ST. TAMMANY PARISH

Addendum No.: 2

Bid#: 24-35-2

Project Name: Diversified Water Well Pretreatment System

CONDUIT WIRE LEGEND

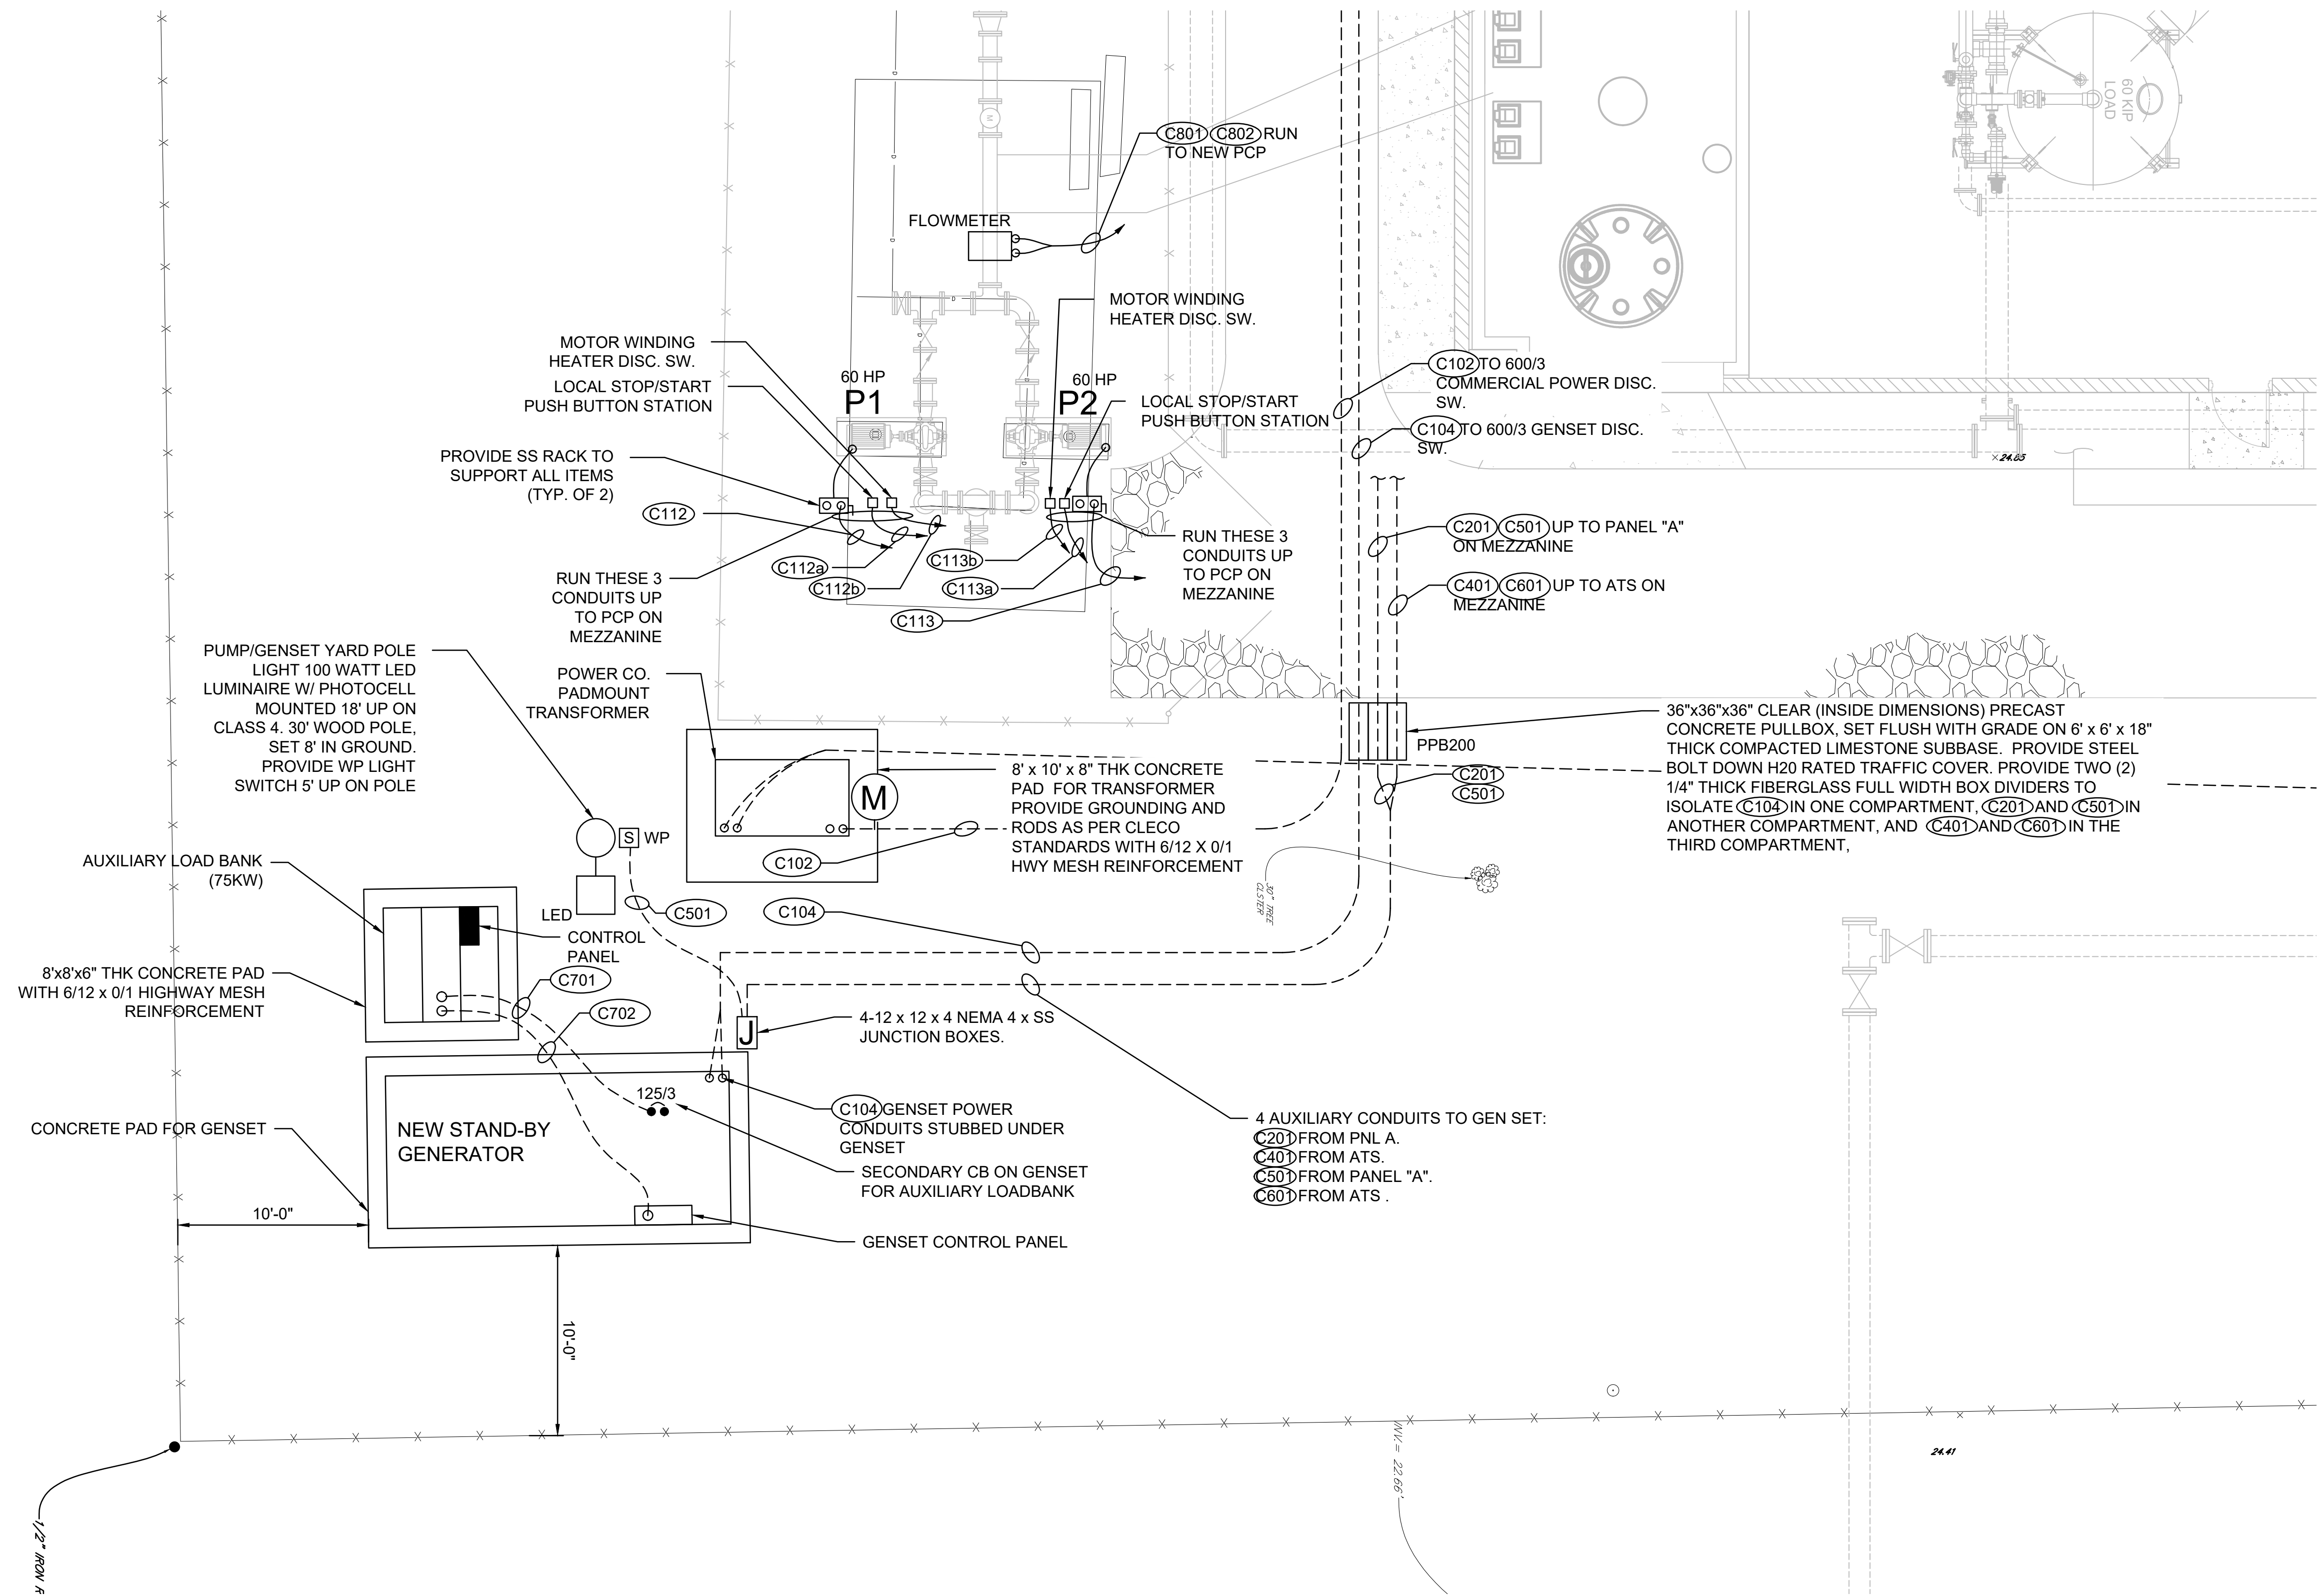
Question 2: Drawing E-004 bottom of page has 4 notes C401, C402, C501 and C601 for conduit and wire sizing however there are not referenced on E-016 Conduit and Wire Chart, please advise to sizing.

Answer 2: Revised Conduit and Wire sizes are indicated on revised electrical sheet E-016, issued with this Addendum.
